RE: **Anderson Heights Unit 5 Park**
Engineer's Stamp Date: 3/12/2018
Hydrology File: N08D006C1

RE: Anderson Heights Unit 5 Park (N08D006C1) -Updated Grading and Drainage Plan

GRADING AND DRAINAGE PLAN

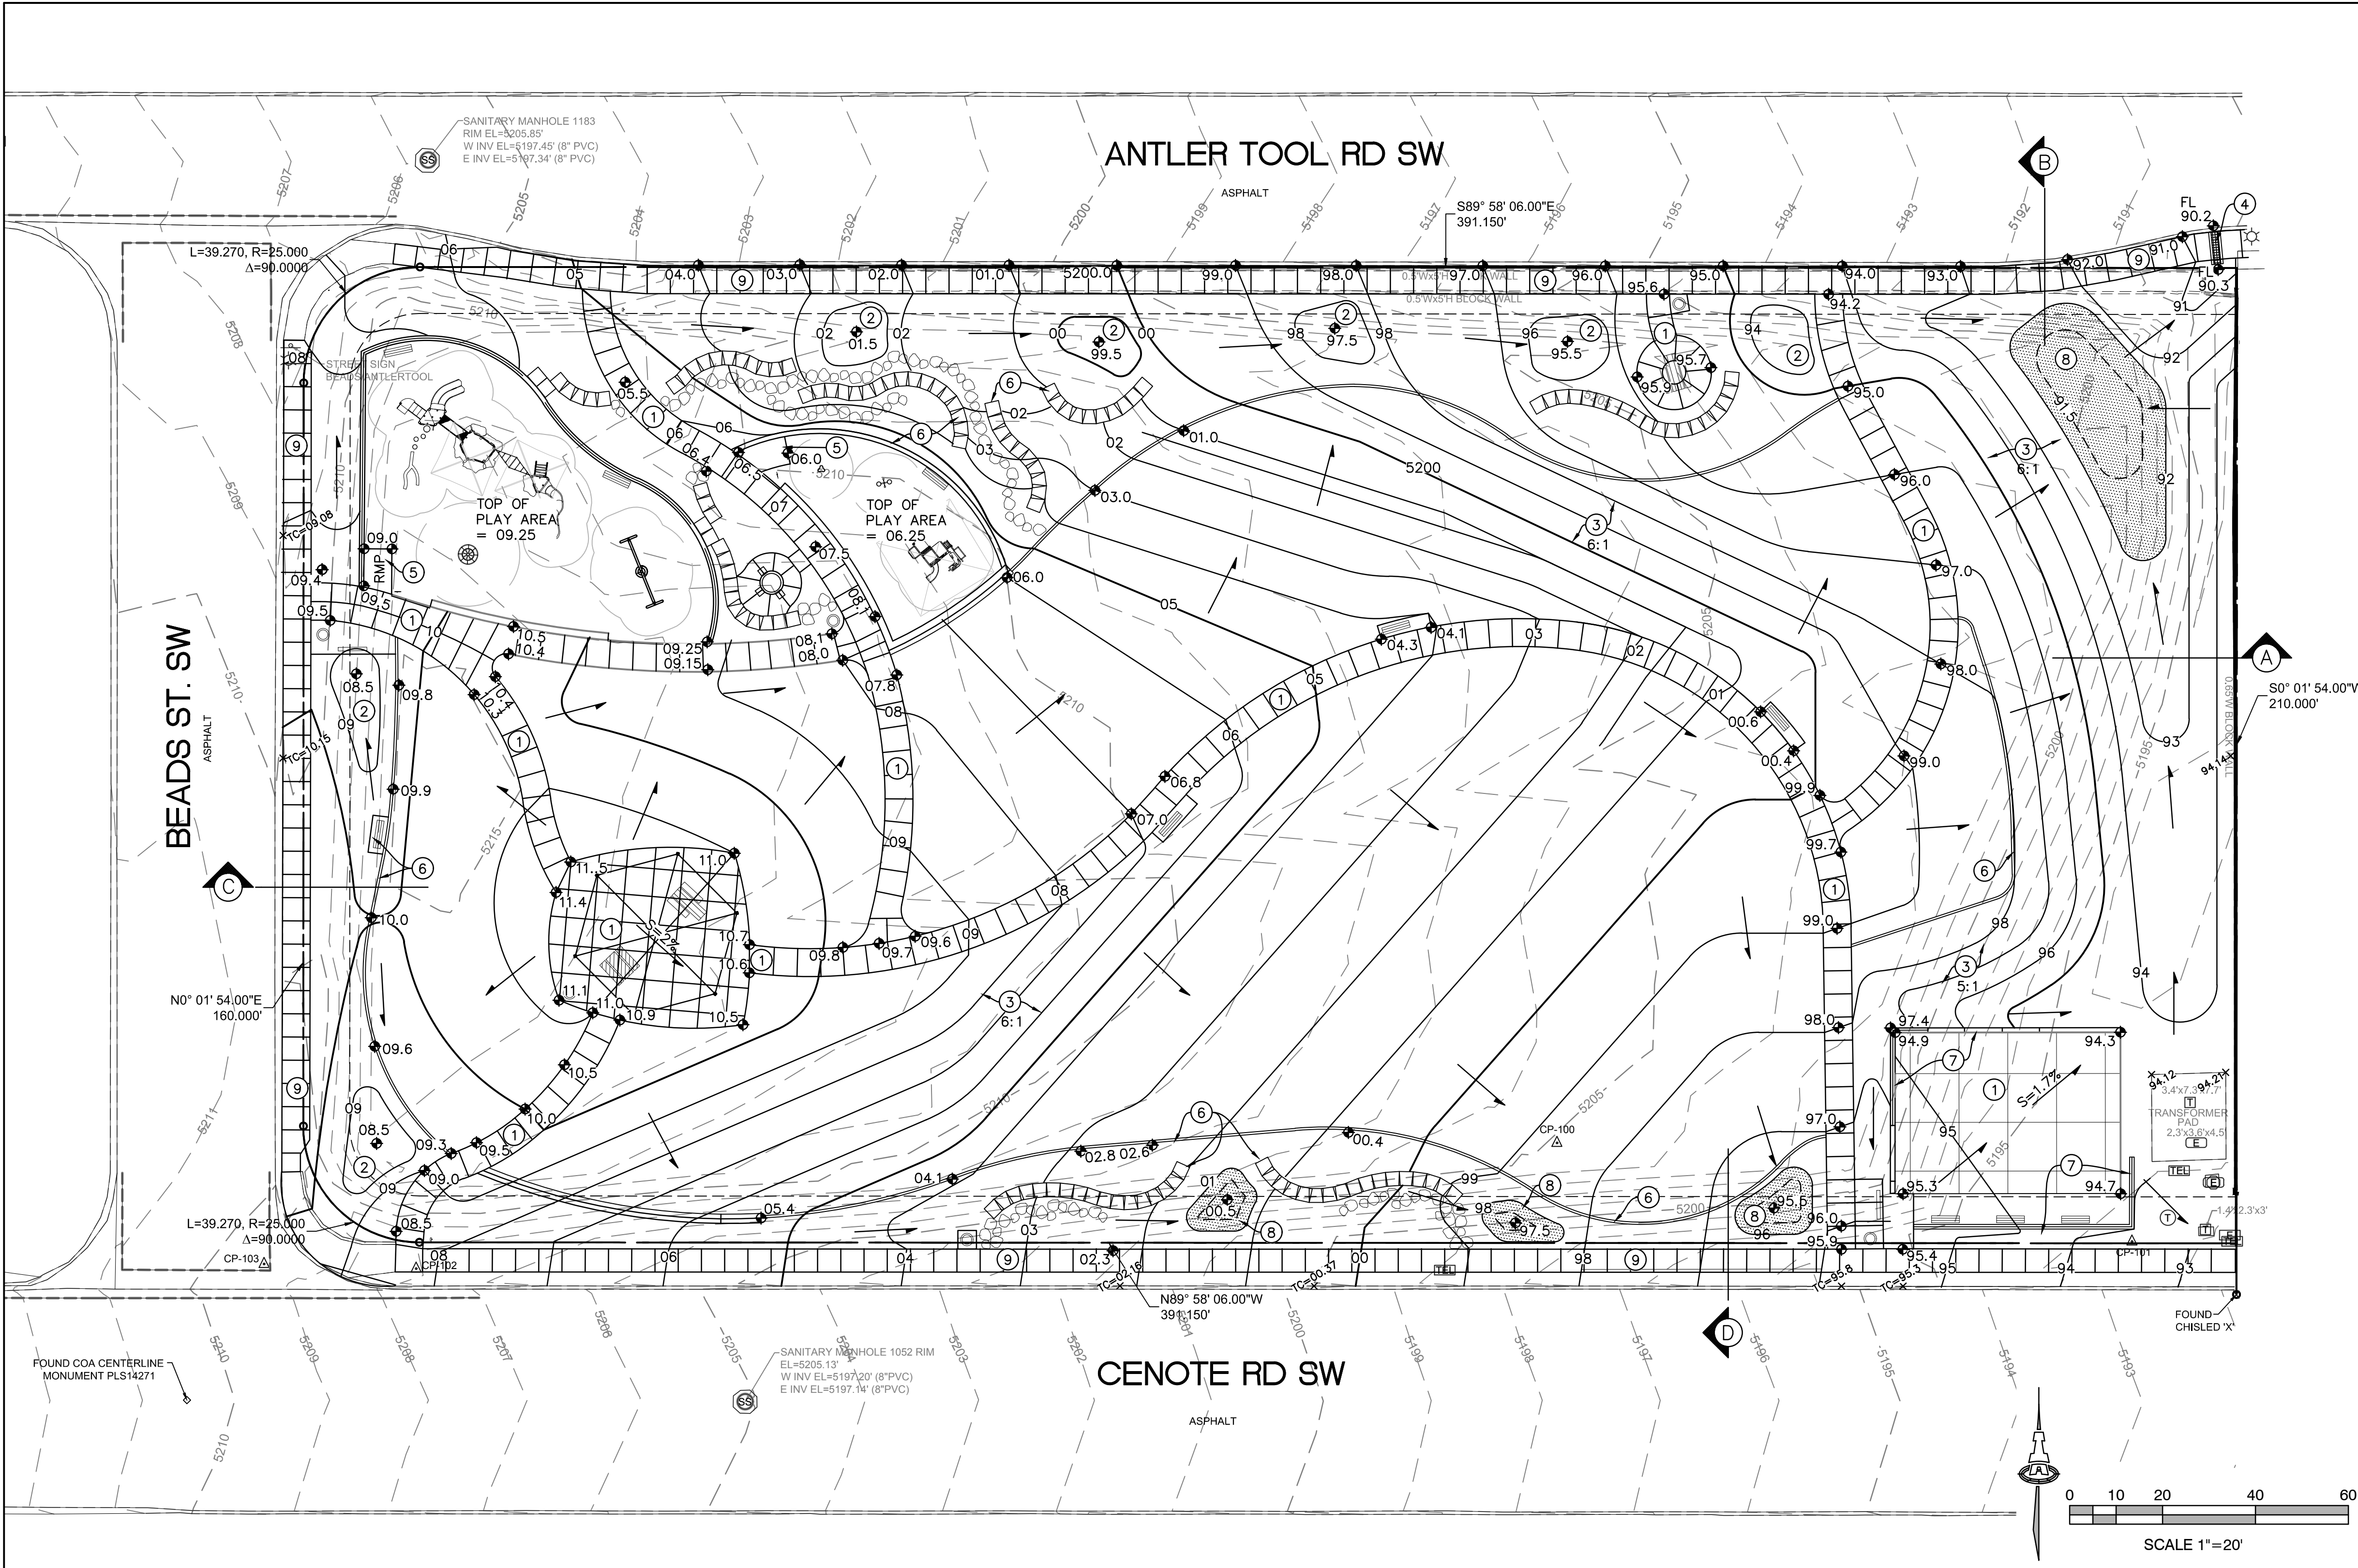
1. A Public Sidewalk Easement must be recorded to contain the Sidewalks around the Perimeter of the site where they are located outside of the public Right of Way. The original notarized easement, covenant, and request for release of covenant must be submitted to Madeline Carruthers along with a \$25 check payable to Bernalillo County for the recording fees for each document to be recorded.
2. The Public Right of way and any other property lines and easements must be clearly indicated on the G&D Plan. The Sidewalk easement in note 1 above must be shown and labeled on the Grading and Drainage Plan along with the recording information.
3. Typical sections should also show cross slopes from the curb to the back of walk (not just in key note) and add the dimensions from the curb to the sidewalk and the width of the sidewalk on the Grading and Drainage Plan.

1. A Public Sidewalk Easement is being coordinated by the project Architect and Surveyor to address the perimeter sidewalks that are located outside of the public right-of-way. The original notarized easement will be submitted to Madeline Carruthers along with a \$25 check payable to Bernalillo County for the recording fee.

2. Sheet 2 notes that Wilson & Co. provided the topographic survey and Rio Grande Surveying provided the property boundary and easement information tied to the topographic survey. These have been added to the plan.

3. Sections through the property showing existing and proposed grade, existing and proposed improvements and the property line for each side of the park have been added. No existing foundations, retaining walls, stable slopes or other structures will be endangered except those that are to be demolished as part of the construction. The existing grades along the east side wall will be matched.

4. A note was added to the plan stating that an Excavation Permit is required for all work in the public right-of-way.
